BID ADDENDUM NO. 1

PROJECT NAME: PORT CHESTER HIGH SCHOOL ADDITIONS, ALTERATIONS
AND ATHLETIC FIELD

F&D PROJECT #: PCHS # 17295.03

DATE: February 14, 2019

DRAWING TITLE PART FIRST & SECOND FLOOR PLANS	
02-12-2019	BID ADDENDUM #1
01-21-2019	BID
07-31-2018	S.E.D. ADD #2
11-13-2017	S.E.D.
08-01-2017	DESIGN DEVELOPMENT
DATE	ISSUED TO
SHEET SIZE 30"x42"	DRAWING NO. PCHS P203
SCALE AS NOTED	FILE NO. 17295.03
DRAWN BY BGA

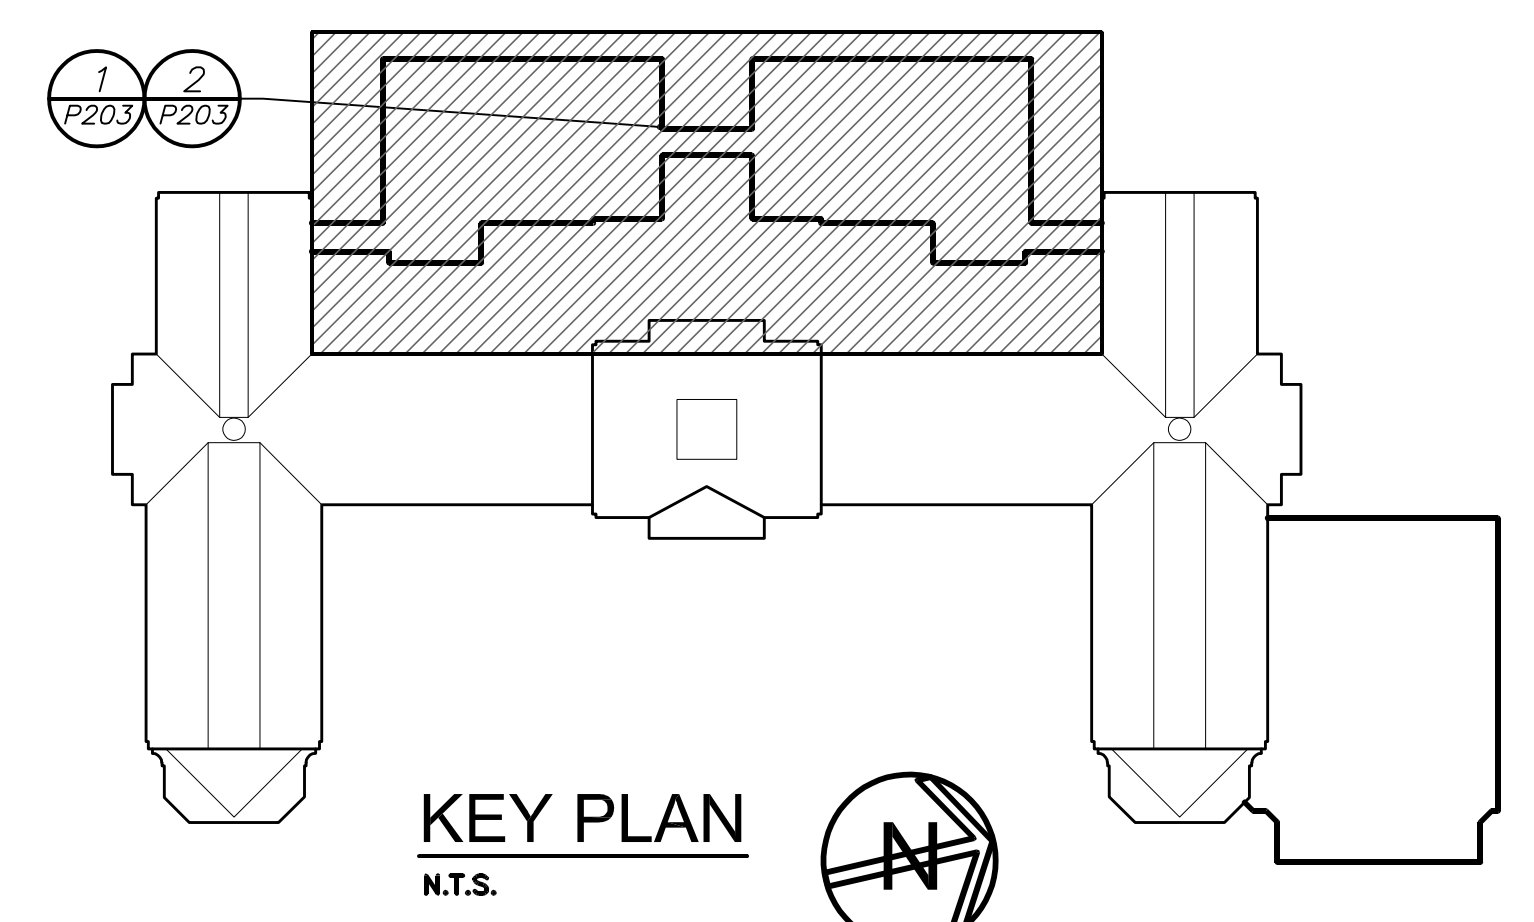
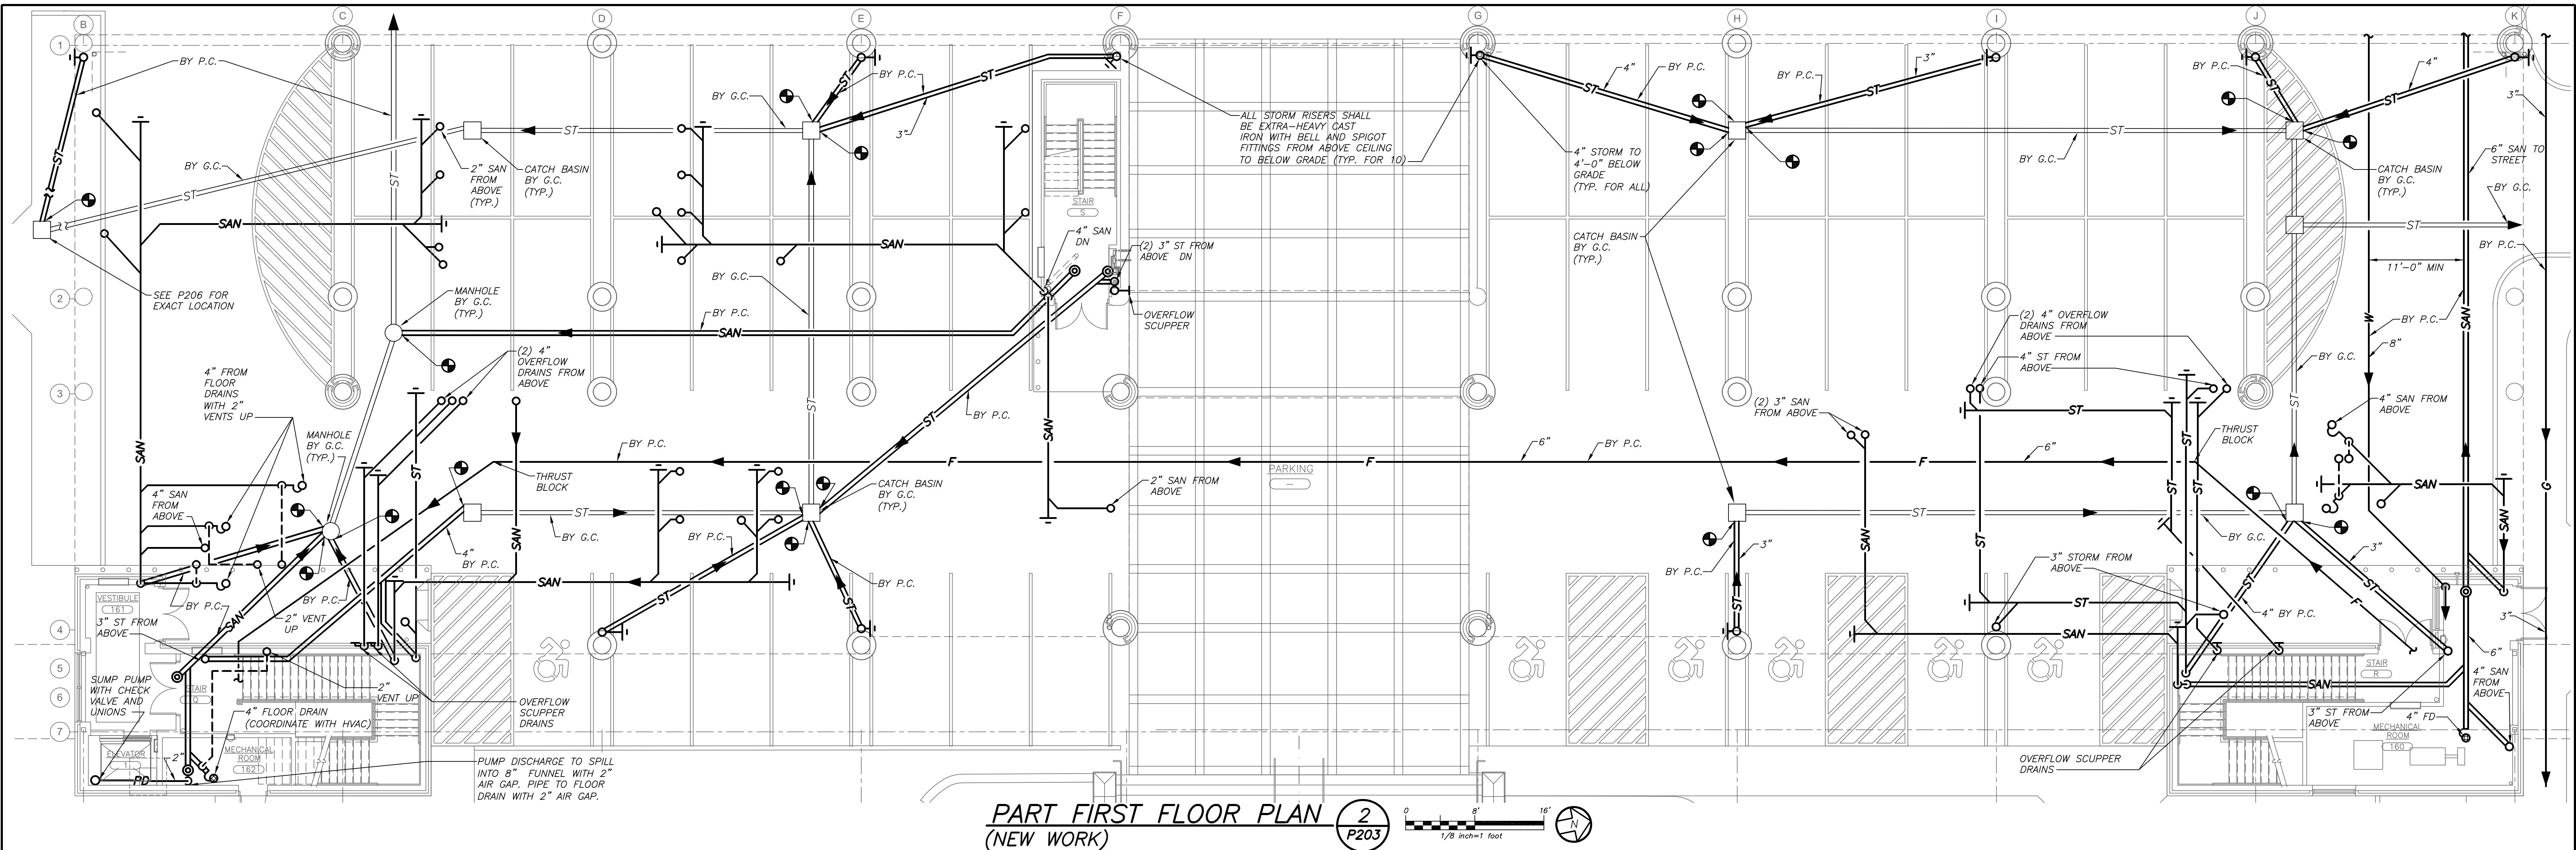
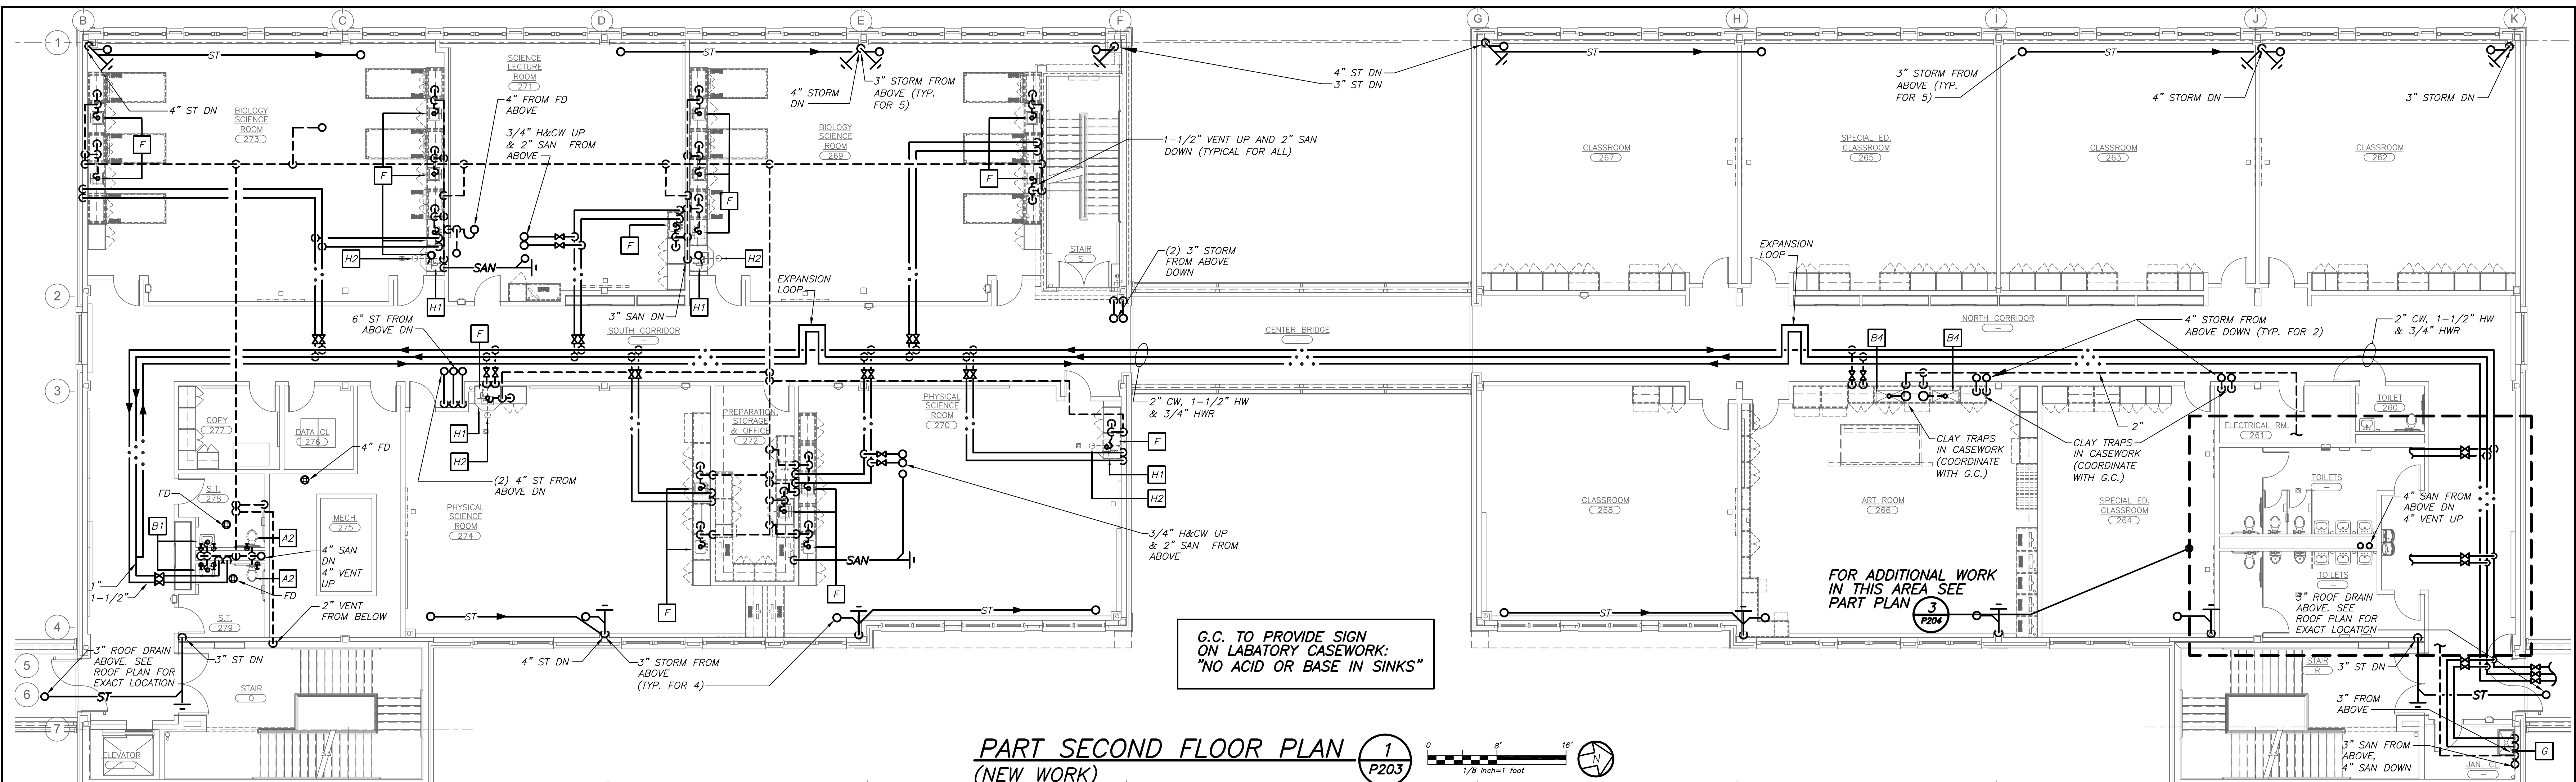
Replace the existing drawing with the attached revised drawing.
Note the 6" sanitary pipe from tair R to exterior parking lot running in between new water and gas lines.
Add: Encase exterior 6" sanitary pipe where the pipe is within 10' or less of the new water pipe in K-Krete or approved equal.

02-13-2019	ADDENDUM #1
DATE	ISSUED TO
SCALE:	AS NOTED
FILE NO.	DRAWING NO.
17295.03	CC-1

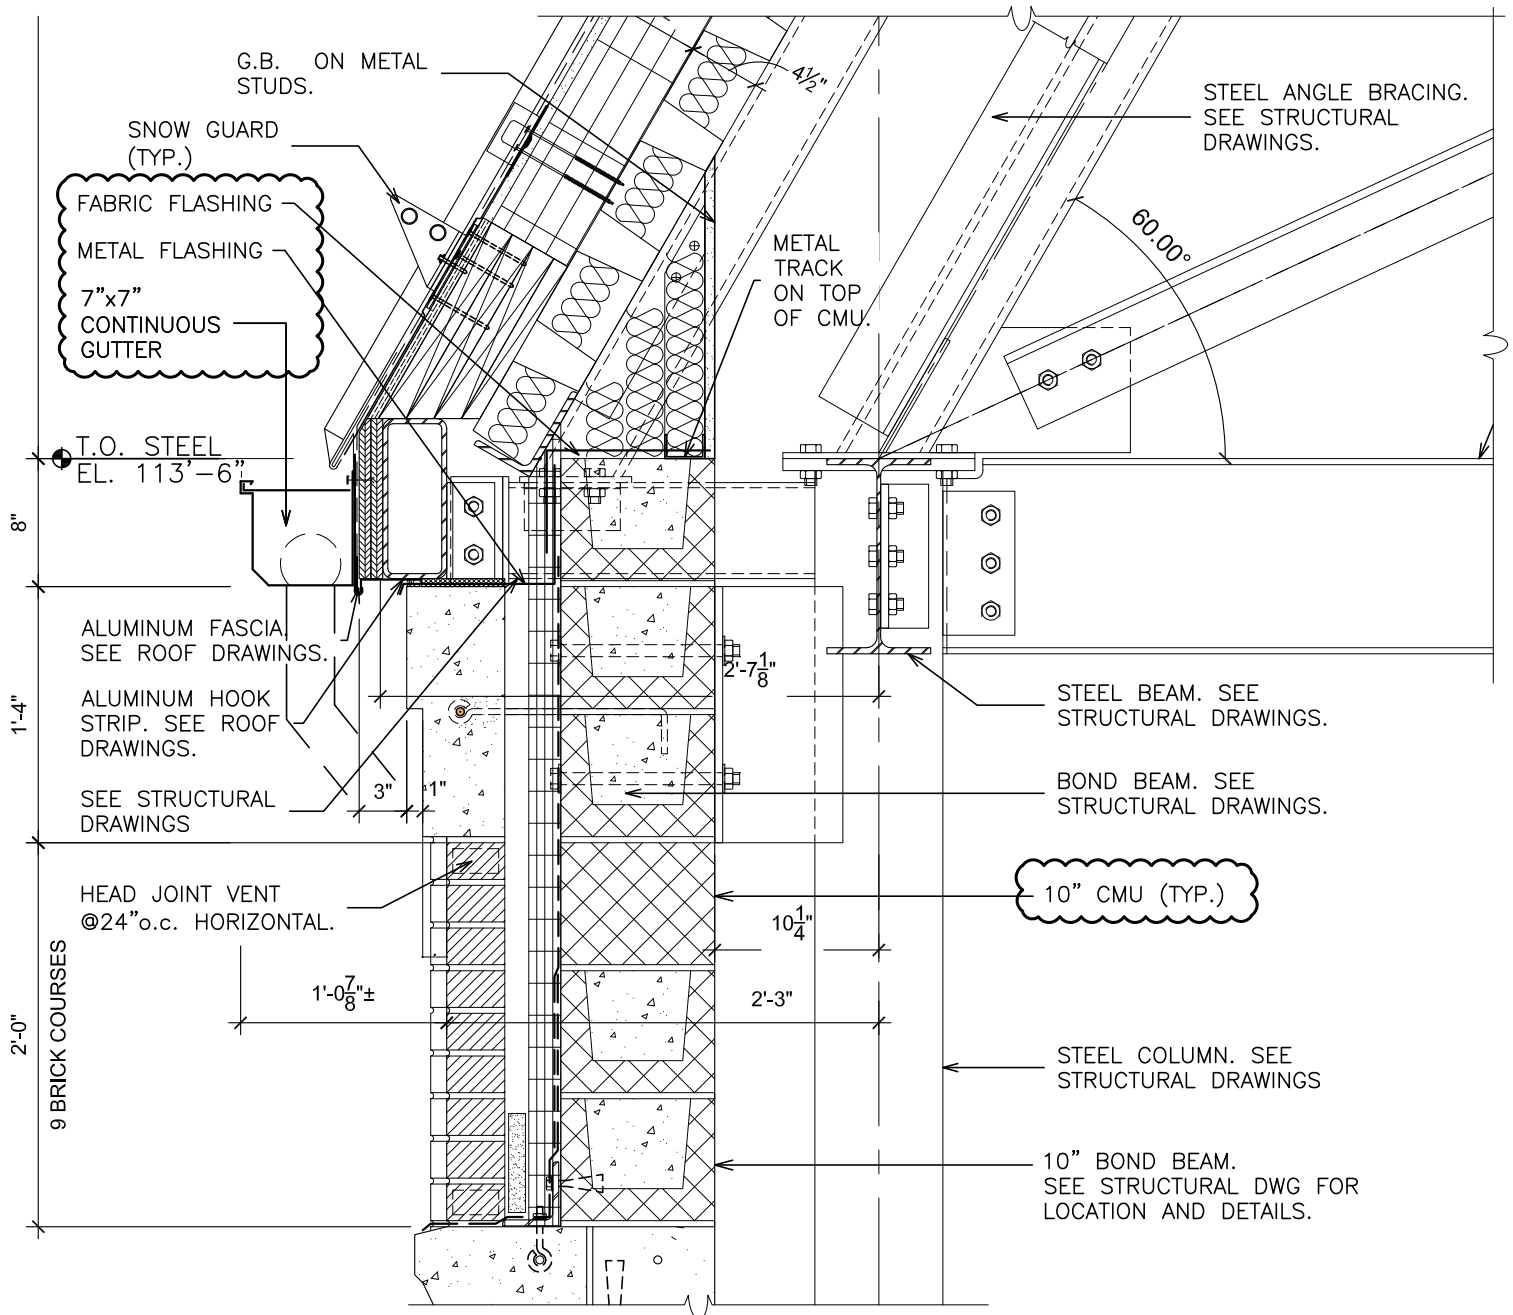
Provide galvanized steel dovetail slots and anchors 16" o.c. vert. for the full height of the concrete foundation walls which are indicated to be faced with masonry.
Delete references to "Korfil block insulation".
Provide air barrier over CMU backup walls. Liquid synthetic rubber. See specs 07 2500, 2.2B.
Provide metal wall ties and reinforcing as per specifications and structural drawings.

02-13-2019	ADDENDUM #1
DATE	ISSUED TO
SCALE:	AS NOTED
FILE NO.	DRAWING NO.
17295.03	CC-2

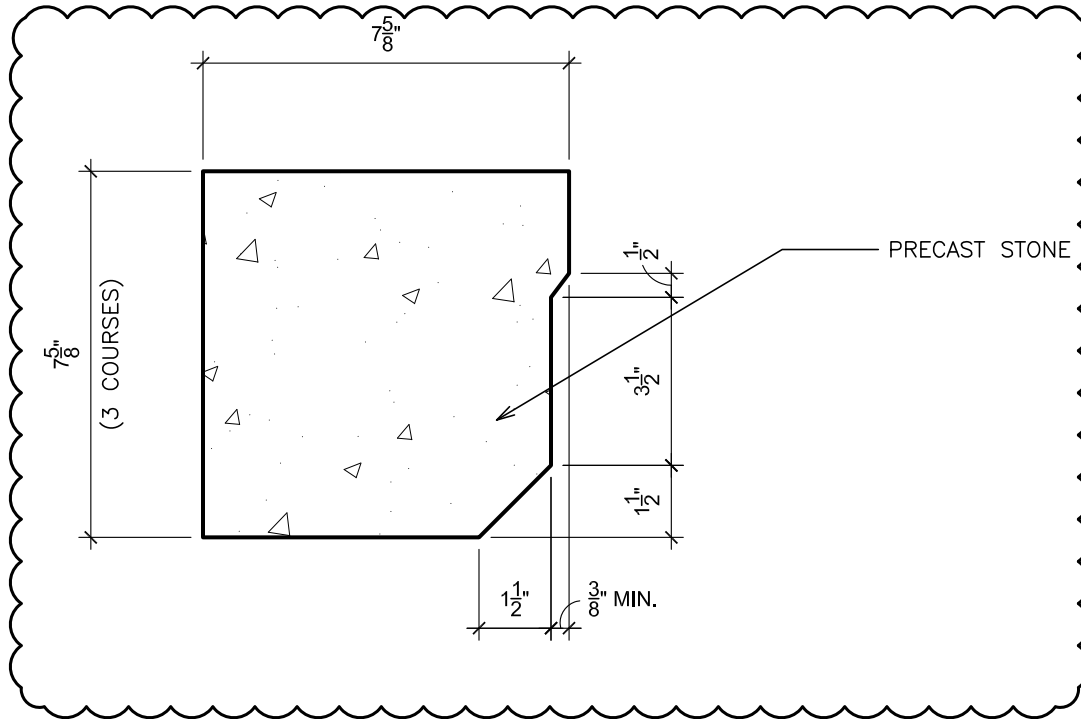
For additional coping details and info see 11/A736.
